BOARD OF WORKS SPECIAL MEETING BY ZOOM

**AIA**[®]**Document G701™ – 2017****Change Order****PROJECT:** *(Name and address)*Greensburg City Hall Renovation
314 West Washington Street, Greensburg,
Indiana 47240**CONTRACT INFORMATION:**Contract For: General Construction
Date: 12/07/2020**CHANGE ORDER INFORMATION:**Change Order Number: 006
Date: 03/23/2021**OWNER:** *(Name and address)*

PROJECT: <i>(Name and address)</i> Greensburg City Hall Renovation 314 West Washington Street, Greensburg, Indiana 47240	CONTRACT INFORMATION: Contract For: General Construction Date: 12/07/2020	CHANGE ORDER INFORMATION: Change Order Number: 007 Date: 04/02/2021
OWNER: <i>(Name and address)</i> Joshua Marsh, Mayor 314 West Washington Street, Greensburg, Indiana 47240	ARCHITECT: <i>(Name and address)</i> DLZ Indiana, LLC 138 N. Delaware St, Indianapolis, IN 46204	CONTRACTOR: <i>(Name and address)</i> Construction Planning and Management, Inc. (CPM) 10053 N. Hague Rd, Indianapolis, Indiana 46256

THIS CHANGE ORDER IS FOR THE COSTS ASSOCIATED WITH THE CHANGES REQUESTED ON PR#007 RECEIVED FROM DLZ,LLC ON 3/4/21.

1 CONFERENCE PLAN - PR007 REMOVAL
 SCALE: 1/4" = 1'-0"
 NORTH

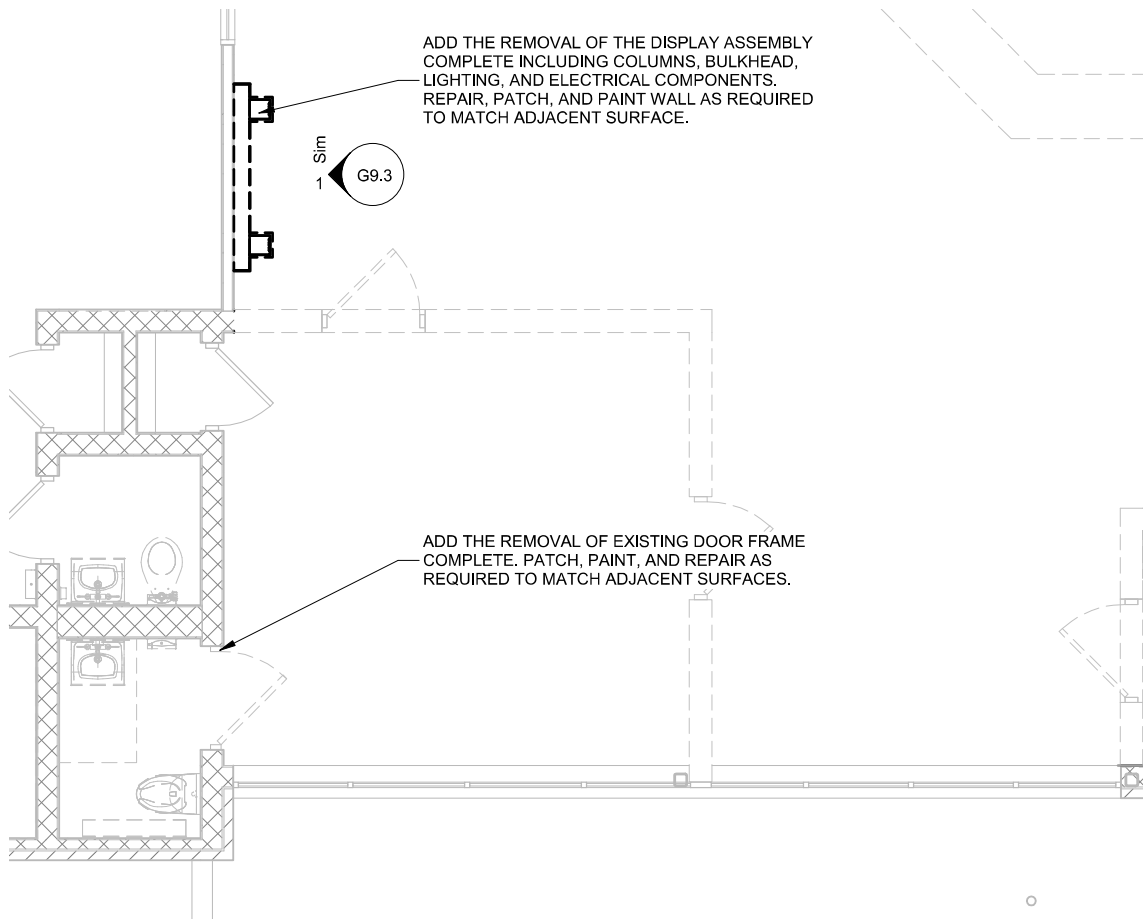
- a) Add the removal of the display assembly complete including columns, bulkhead, partition wall and lighting. Repair, patch and paint the wall as required to match adjacent surface as indicated on attached drawings.
- b) Revise the ceiling plan to accommodate the removal of display assembly as shown in attached drawings.

WOOD VENEER AND COLUMNS
TO BE REMOVED. OWNER HAS
RIGHT OF FIRST REFUSAL

STUD DISPLAY WALL TO BE REMOVED.
PATCH, PAINT, AND REPAIR EXISTING WALL
TO MATCH ADJACENT SURFACE.

1 DISPLAY REMOVAL ELEVATION

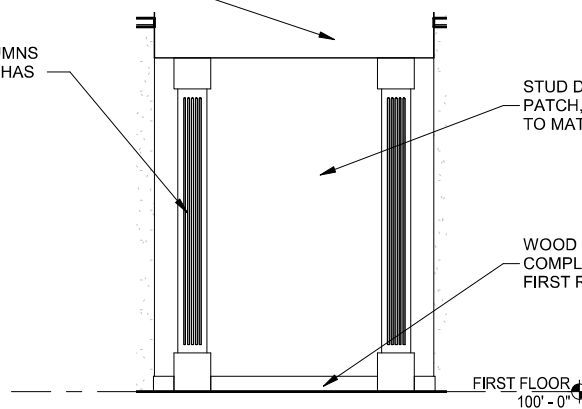
WOOD BASE TO BE REMOVED
COMPLETE. OWNER HAS RIGHT OF
FIRST REFUSAL

CONFERENCE A104 CEILING PLAN

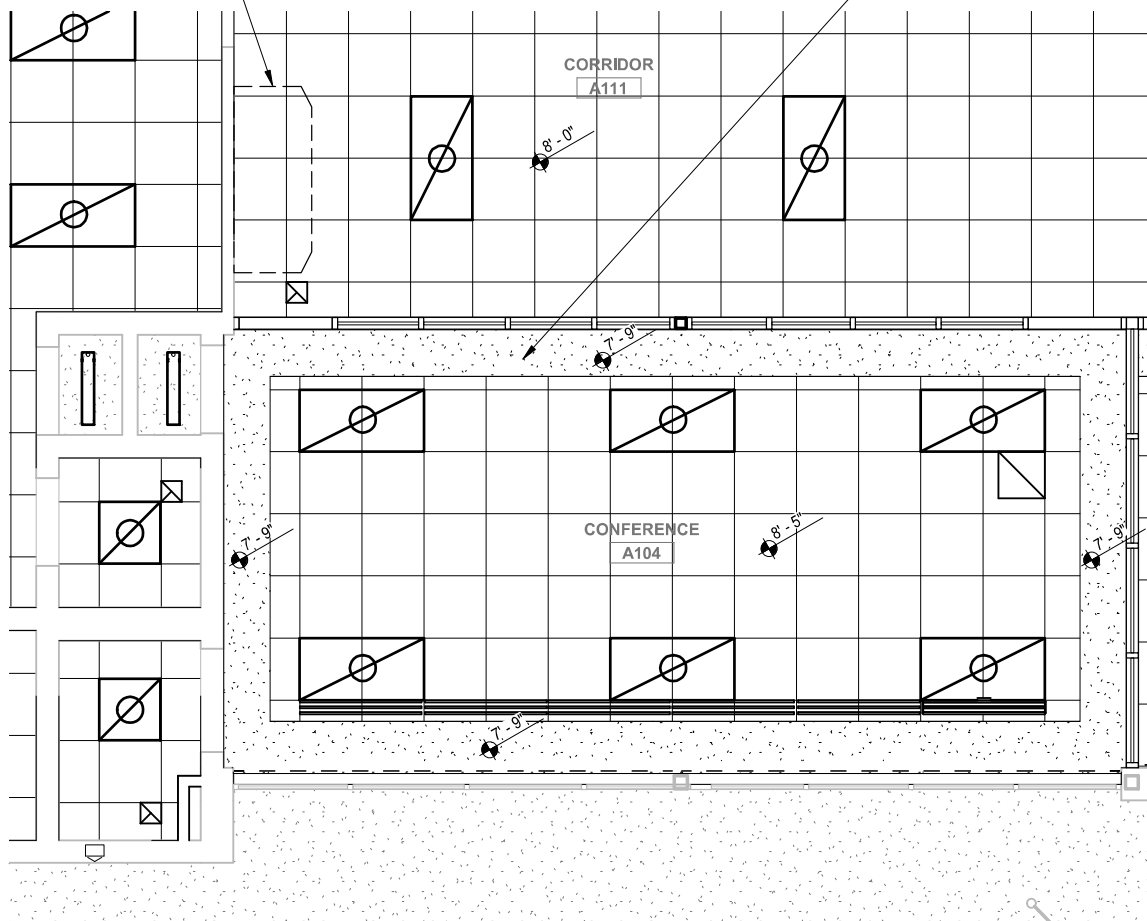
REVISE CEILING PLAN AS SHOWN
TO ACCOMMODATE REMOVED
DISPLAY WALL

LOWER HEIGHT OF PERIMETER
BULKHEAD BY 3" TO A NEW
HEIGHT OF 7'-9"

1 PLANNING MEETING ROOM CEILING PLAN

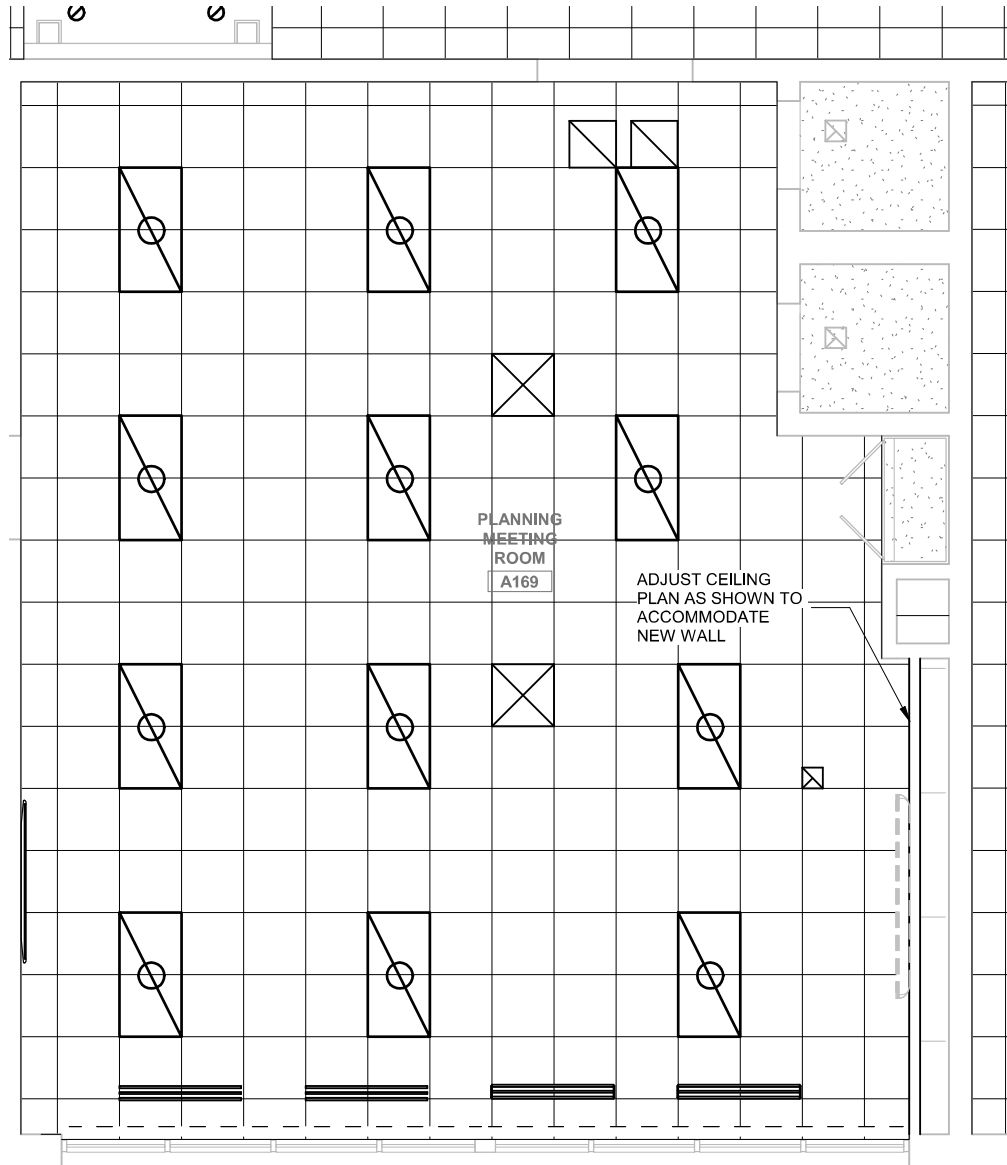
- a) Add a new partition wall along the East side to conceal wall imperfections on existing wall as indicated on attached drawings.
- b) Revise lighting plan in Planning Meeting Room as shown in attached Electrical Drawings.
- c) Revise power/data as shown in attached Electrical Drawings.
- d) Revise demo status of devices behind furred out East wall as shown in attached Electrical Drawings.

PLAN DIRECTOR'S OFFICE PLAN

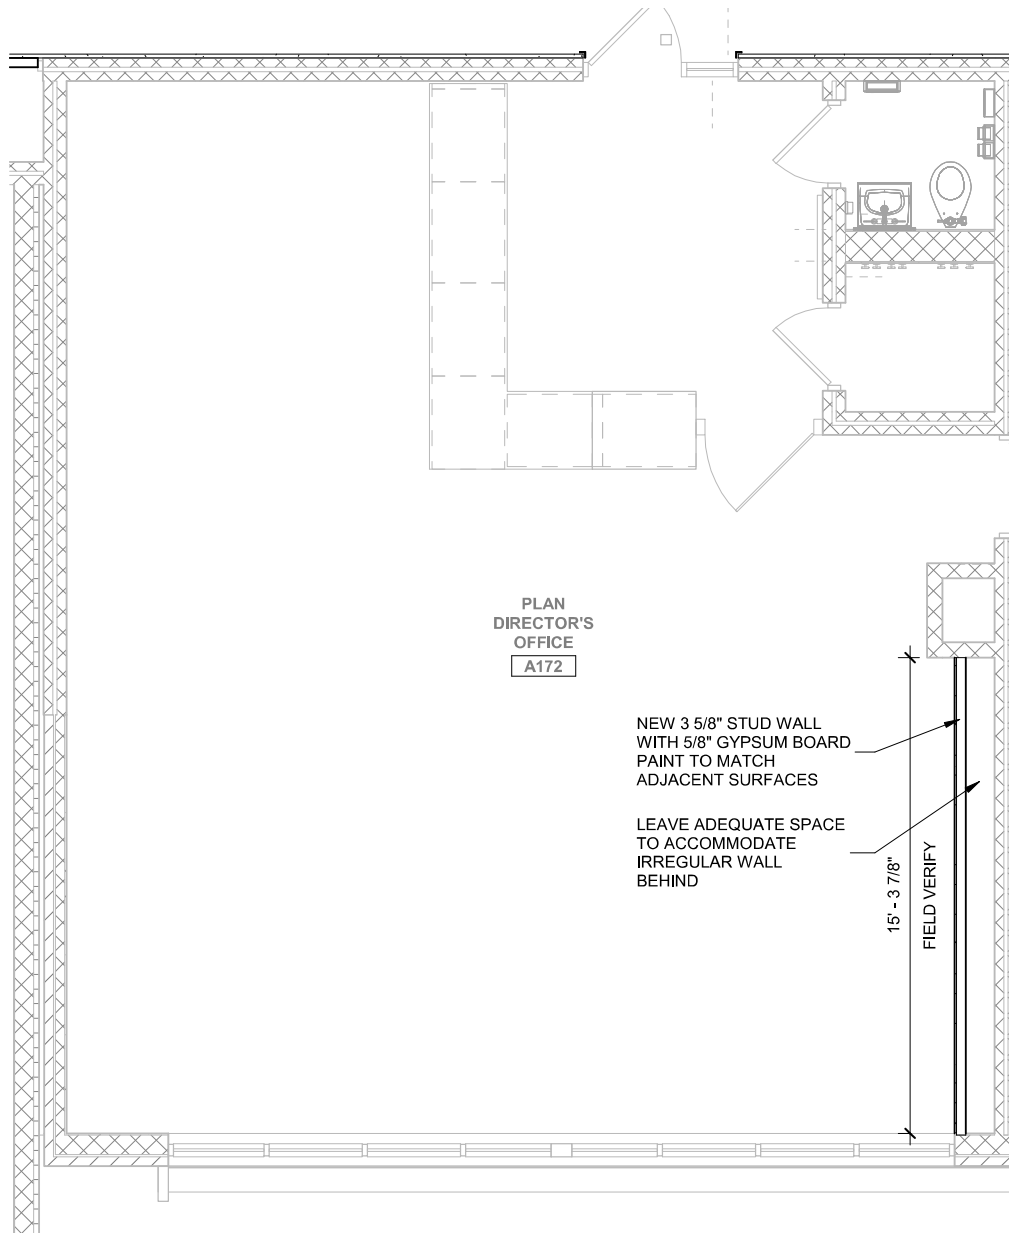
- a) Add a new partition wall along the East side to conceal wall imperfections on existing wall as indicated on attached drawings.
- b) Revise lighting plan in Plan Director's Office as shown in attached Electrical Drawings.
- c) Revise power/data as shown in attached Electrical Drawings.
- d) Revise demo status of devices behind furred out East wall as shown in attached Electrical Drawings.

5 INFILL EXISTING MASONRY WALL OPENING
SCALE: N.T.S.

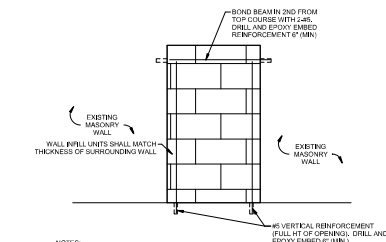
- b) Revise ceiling plan eliminating the folding partition wall pocket as indicated on the attached drawings.
- c) Infill existing recesses with CMU and add fabric wrapped acoustical panels on the south wall as indicated on the attached drawings.

1 HYDRONIC PIPING INSTALLATION PLAN - UNIT B
SCALE: 1/8" = 1'-0"
NORTH

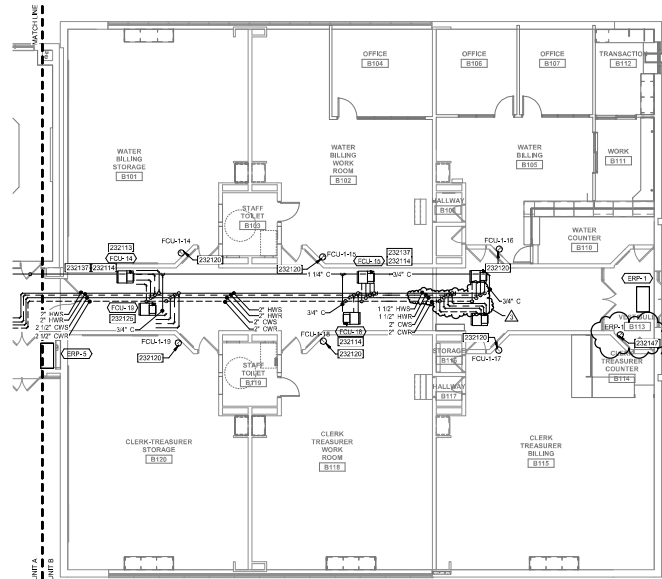
Item No. 13 M3.2 - Hydronic Piping Installation Plan - Unit B

GREENSBURG CITY HALL
RENOVATION OF THE
314 WEST WASHINGTON STREET
GREENSBURG, INDIANA 47240
PARTIAL SITE PLAN - ELECTRICAL

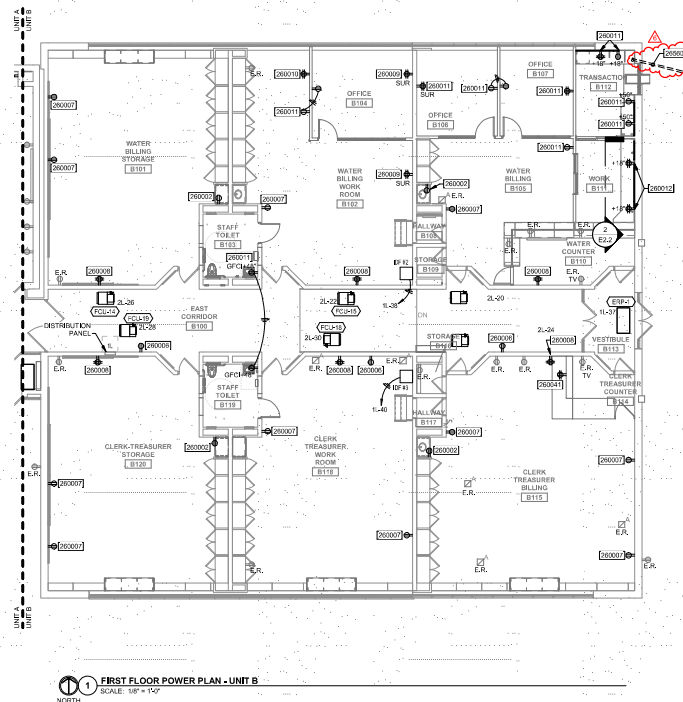
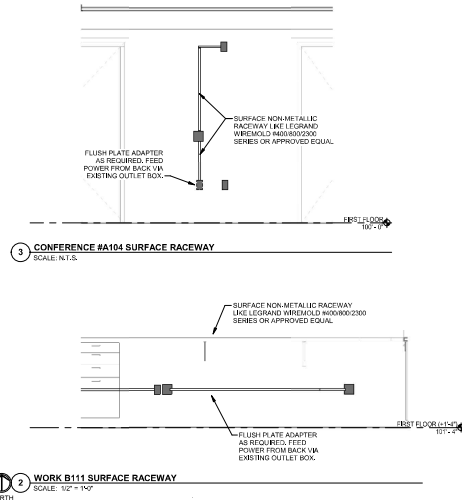
Item No. 18 E1.0 - Partial Site Plan - Electrical

- a) Add raceways between Transaction B112 and Island for future power and communications cabling.
